Applied	5/21/2019 DG
Project Number	SP2019-018	**Owner**	SARO Partners LLC	**Approved**	
Project Name	Office/Warehouse	**Applicant**	Platimum Construction	**Closed**	
Type	SITE PLAN			**Expired**	
Subtype				**Status**	
Status	Staff Review

SP2019-018 Site Plan for Office/Warehouse: Please address the following comments (M= Mandatory Comments; I = Informational Comments)

1. This is a request by Annalyse Valk of Platinum Construction on behalf of Shawn Valk of Saro Partners, LLC for the approval of a site plan for a multi-tenant office/warehouse facility on a 2.21-acre tract of land identified as Lot 6, Block A, Bodin Industrial Addition, City of Rockwall, Rockwall County, Texas, zoned Light Industrial (LI) District, addressed as 1491 T. L. Townsend Drive.

TO:	Planning and Zoning Commission
DATE:	June 11, 2019
APPLICANT:	Annalyse Valk; Platinum Construction
CASE NUMBER:	SP2019-018; *Site Plan for Office/Warehouse at 1491 T. L Townsend Dr.*

Project No.	17031
Drawn By	S.R.
Checked By	R.R.
Date	5/16/2019
Scale	AS SHOWN
Sheet No.	3 of 7

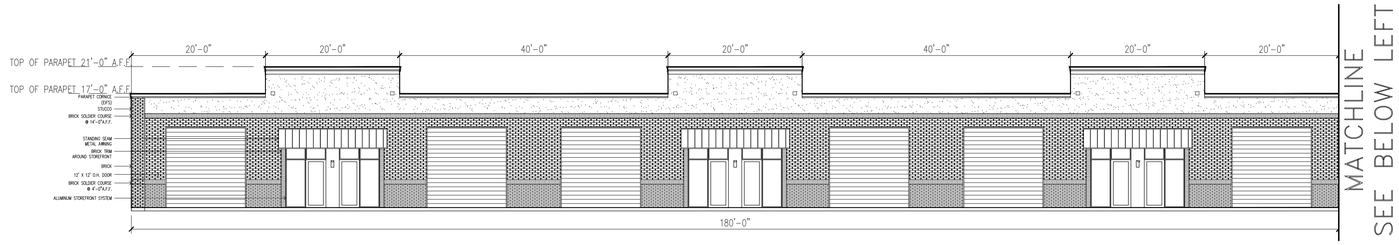
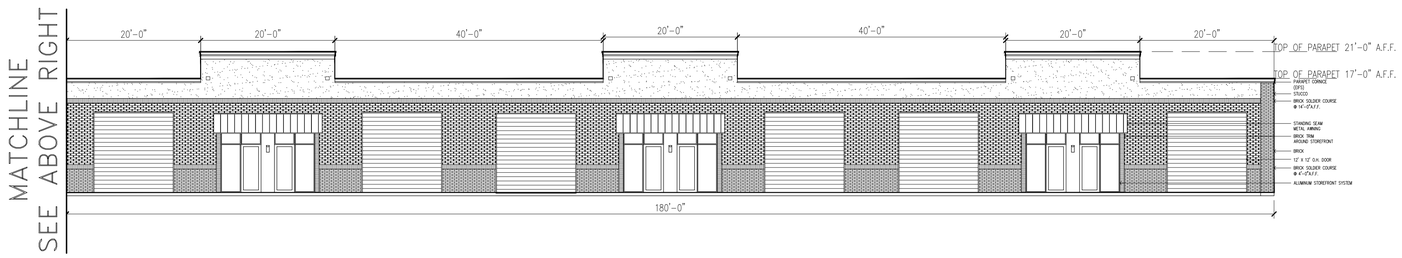
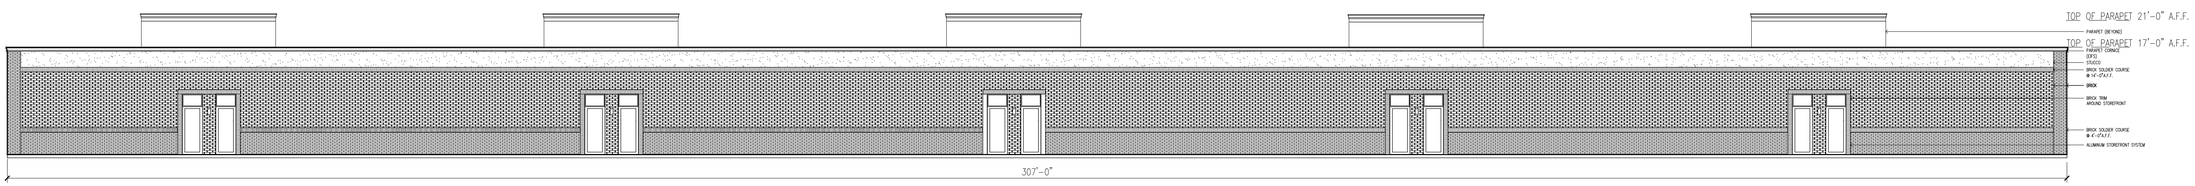
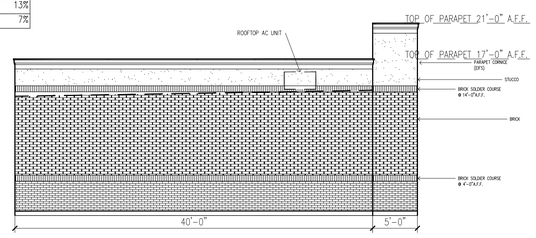
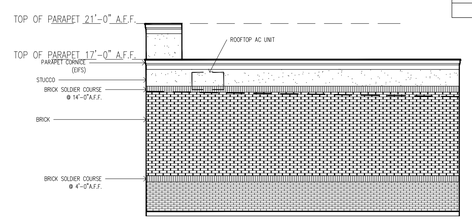
45. Sheet E1.1—Please note that the building footprints are not consistent with site plan and landscape plan.
46. Sheet A-2—Please add site data table
47. Sheet A-2—Please note that each building needs its own set of elevations.

48. Sheet A-2—Please indicate which elevation faces the street.
49. Sheet A-2—Please note that as drawn, the building elevations will need several variances: vertical and horizontal articulation, 4-sided architecture, no stone. All 4 sides of the buildings will need to be architectural finished with the same materials and elements as the front.

50. Sheet A-2—Please note that the min stone requirement is 20%
51. Sheet A-2—Please dash-in rooftop units on all elevations and show how they will be screened.

52. Sheet A-2—Please note that although this sheet refers to Building B, the two material percentage charts at the bottom of the page refer to Building A.

53. Sheet A-2—Building B, South Elevation notes the same scale as the North Elevation, however, they are not drawn to the same scale.
54. Sheet A-2—Building B, North Elevation appears to show a tower element projecting from the facade; however, the South Elevation does not show a projecting element.

S-1

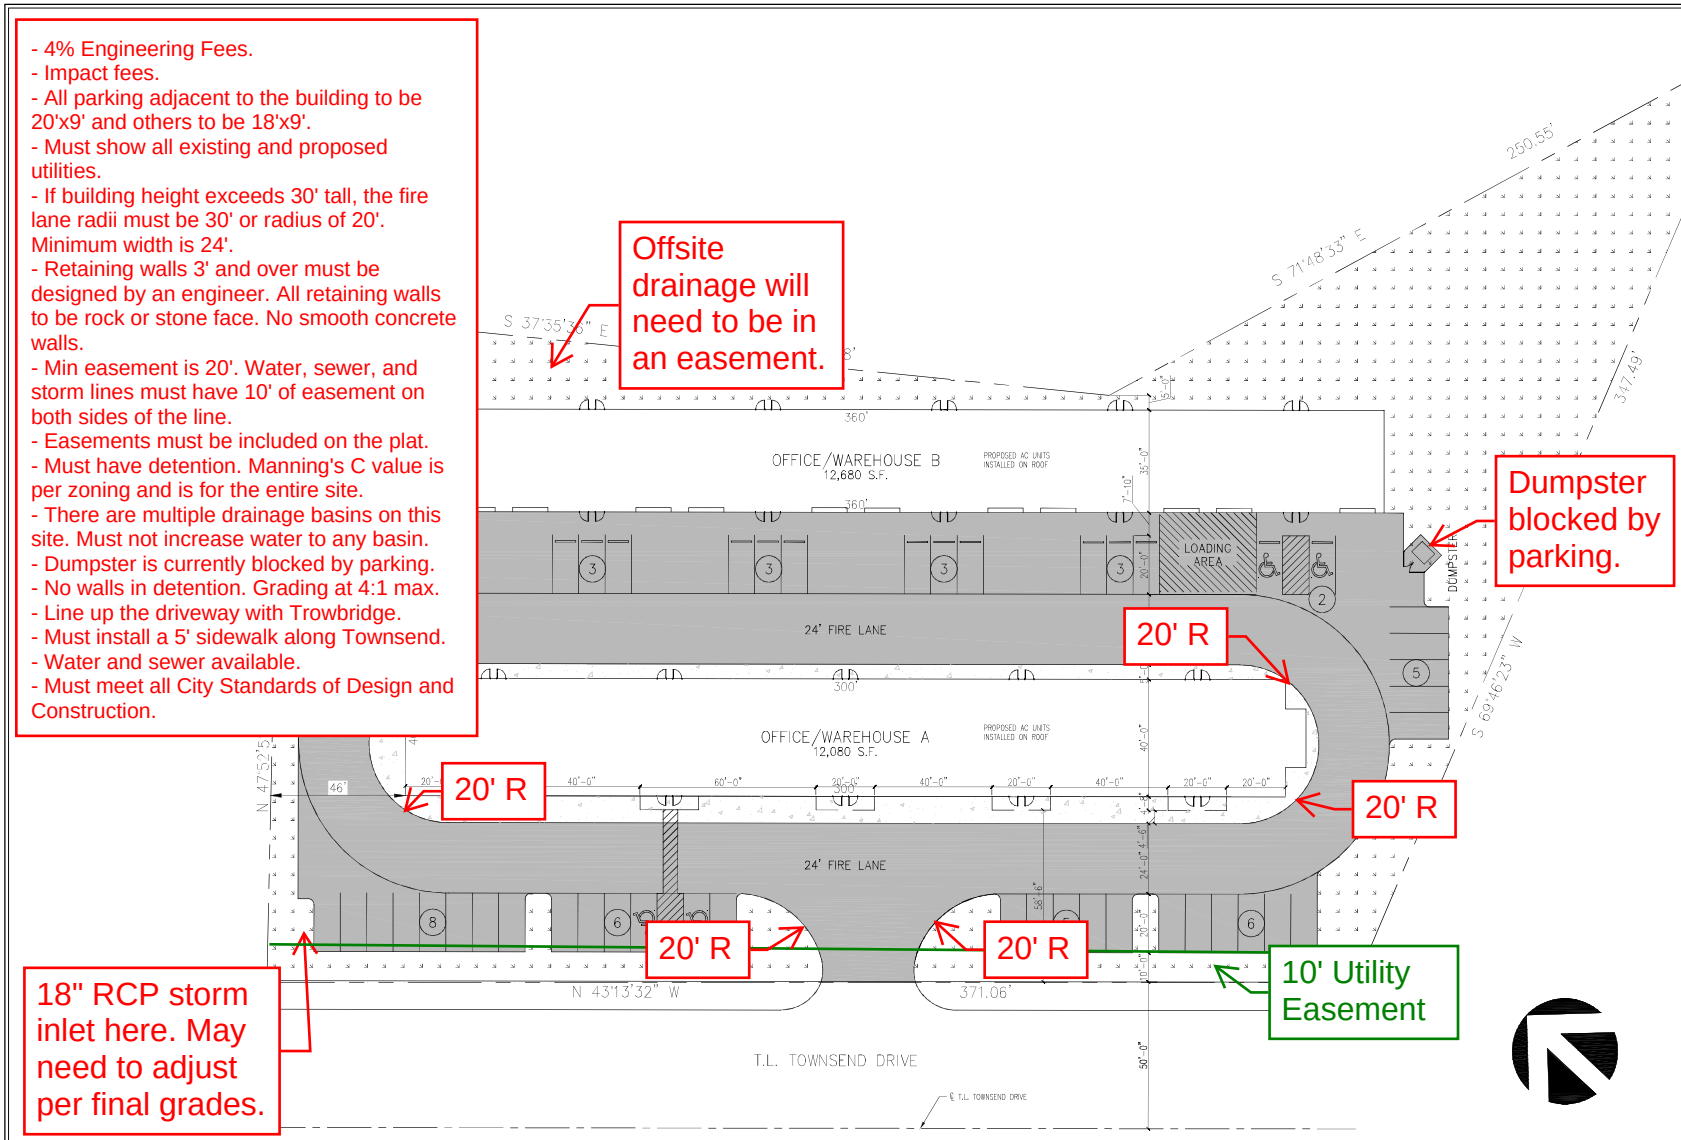
- There are multiple drainage basins on this site. Must not increase water to any basin.
- Dumpster is currently blocked by parking.
- No walls in detention. Grading at 4:1 max.

- Line up the driveway with Trowbridge.
- Must install a 5' sidewalk along Townsend.
- Water and sewer available.
- Must meet all City Standards of Design and Construction.

sheet
L-1

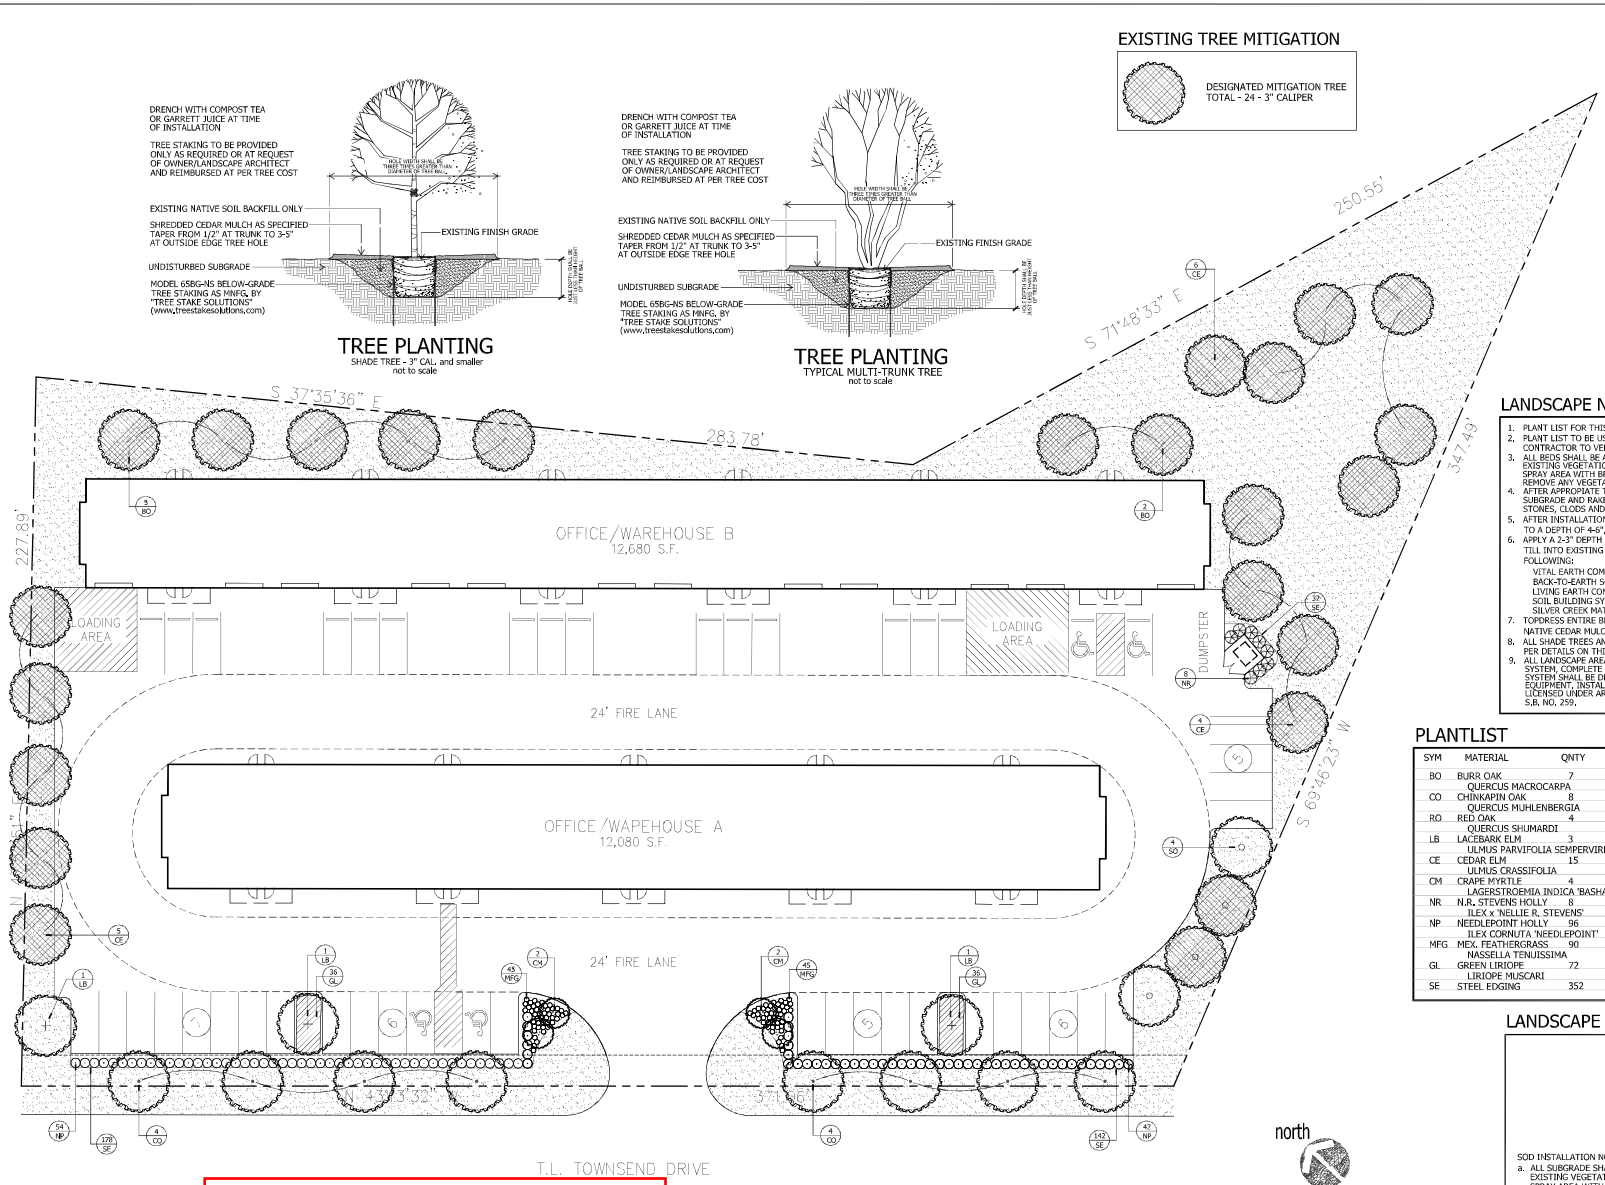
No trees within 5' of water line in Townsend Blvd. ROW.
ROW must be sodded prior to acceptance.

sheet
T-1

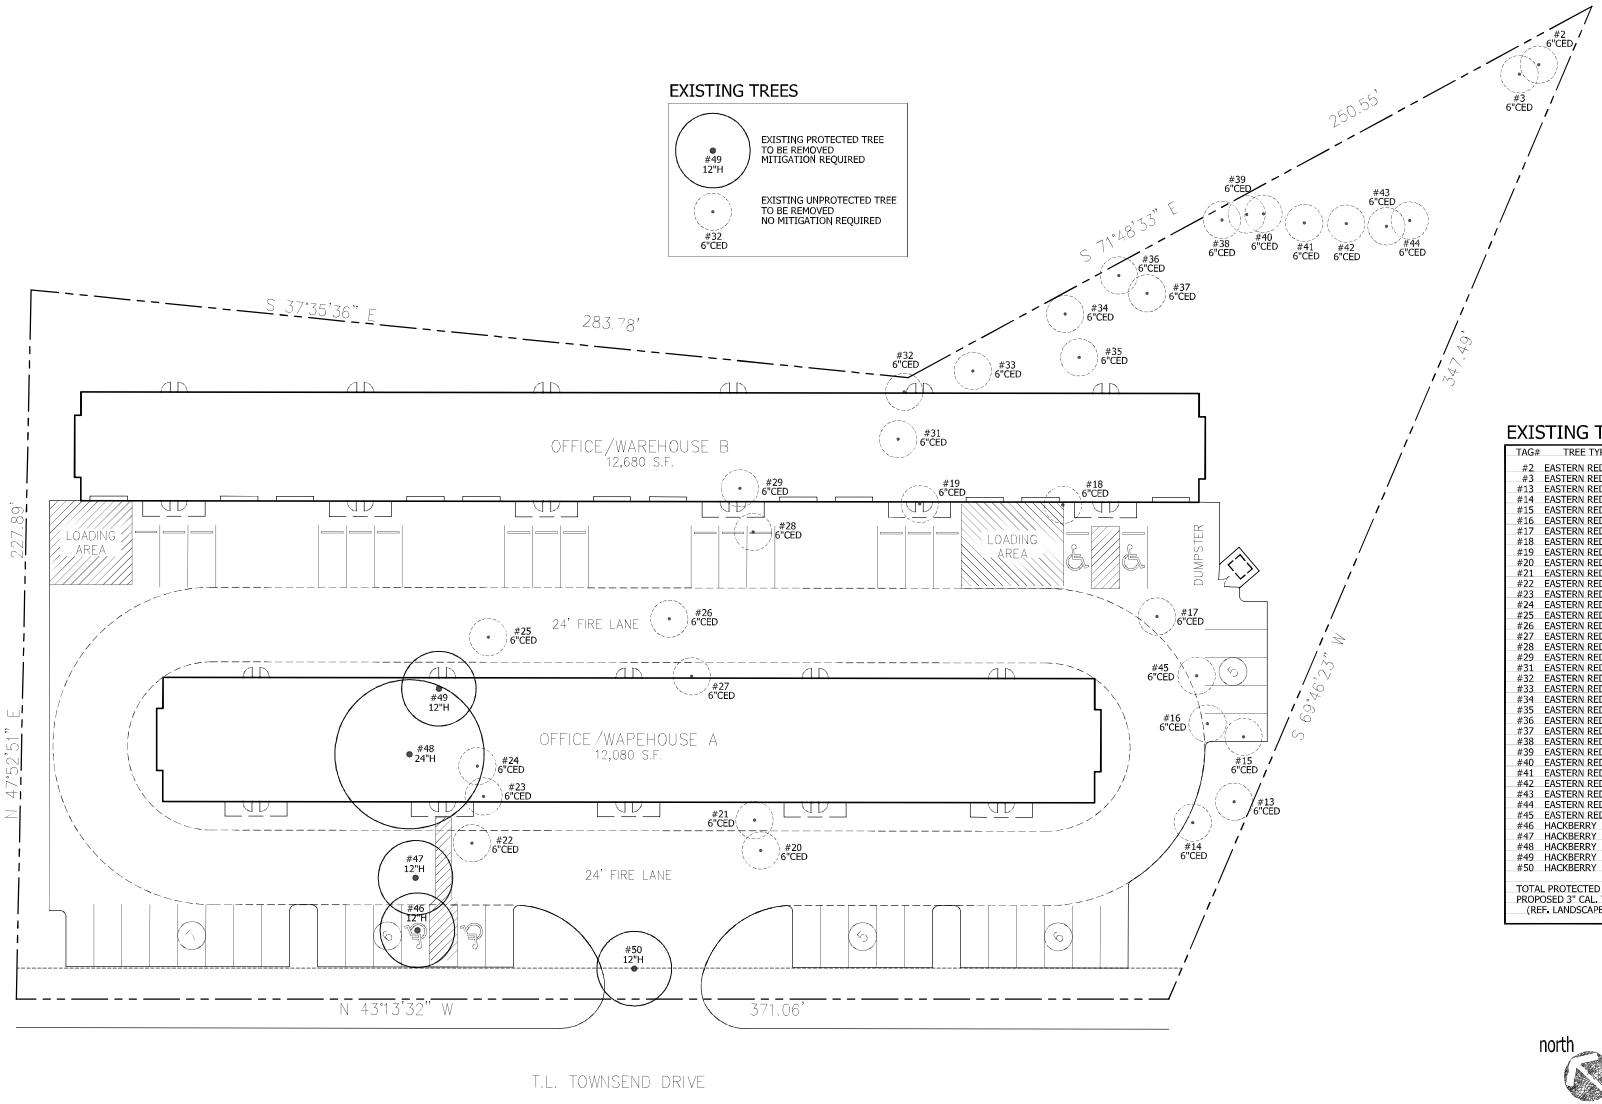
No trees within 5' of water line in Townsend Blvd. ROW.
ROW must be sodded prior to acceptance.
